Official Recall Notification U.S. Federal Boat Safety Act: Improper Overcurrent Protection on Starter Solenoid and Alternator Sense Circuit

Models Affected

Models Covered	Serial Number Range
HP525 EFI	0M900146 through 0M962496
HP600 Sci, HP662 Sci, HP700 Sci	
HP850 Sci, HP1075 Sci, HP1200 Sci

Fuse Installation

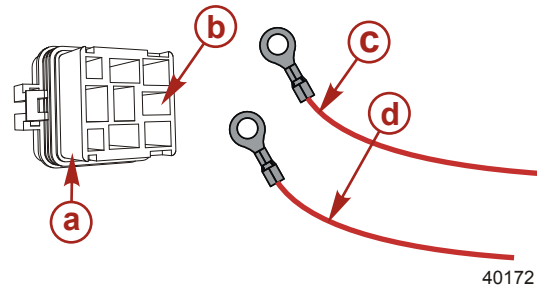
The engine and alternator harnesses have improper overcurrent protection. If an electrical overload condition develops in either of these two circuits, the condition may cause the conductor to overheat and could cause an electrical fire in the harness. A kit to rectify this situation is available from Mercury Racing.

1. Turn off the battery switch for the engine or disconnect the battery ground cable.
2. Locate the two 8 gage wires (14-Pin engines), or three 8 gage wires (older 10-Pin 525 engines), that are connected to the 90 Amp fuse on the starter solenoid and remove them from the fuse connection.
3. Locate the 8 gage wire with two wires crimped to the connector (one 8 and one 18 gage wire).
4. Strip the heat shrink from the connector and cut the 18 gage wire close to the connector. Strip ¼ in. of the insulation from the end of the 18 gage wire.
5. Connect the 18 gage wire to the open lead on the 5 Amp fuse assembly with the supplied butt splice. Apply heat to the splice to seal the wires.
6. Slide the heat shrink sleeve over the smaller end of the 50 Amp fuse assembly.

a - Main power relay connector
b - Position 1

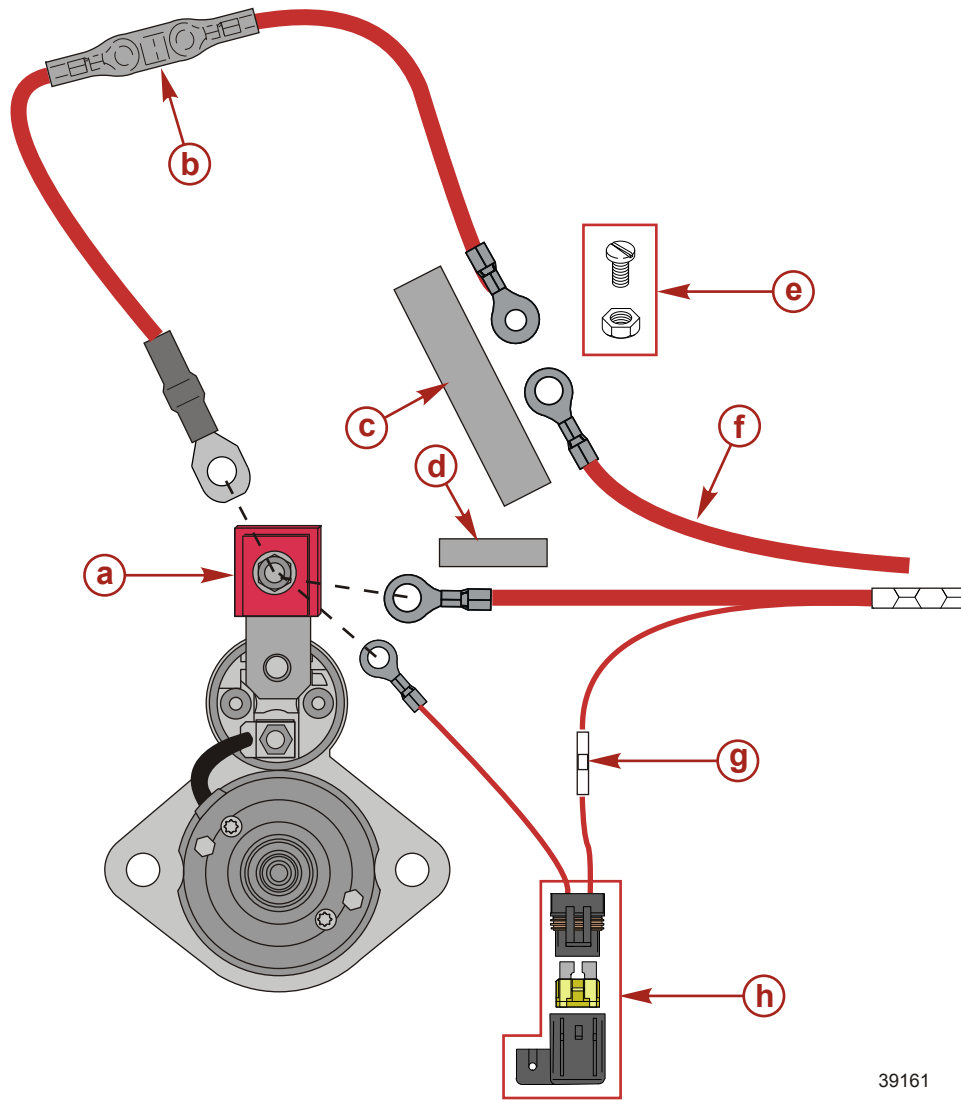
IMPORTANT: Use an ohmmeter to locate the proper wire to connect the 50 amp fuse to on engines equipped with a 10-Pin harness connecting the engine harness to the helm.

7. With the wires disconnected from the 90 amp fuse, find the wire that feeds the Main power relays. Connect an ohmmeter from the ring terminal to the #1 position on the Main Power relay connector. Use that wire in the next step.
8. Connect the smaller connector of the 50 Amp fuse assembly to the 8 gage wire that feeds the main power relays with the nut and bolt. Slide the heat shrink sleeve over the connectors and apply heat to the sleeve to seal the connection.
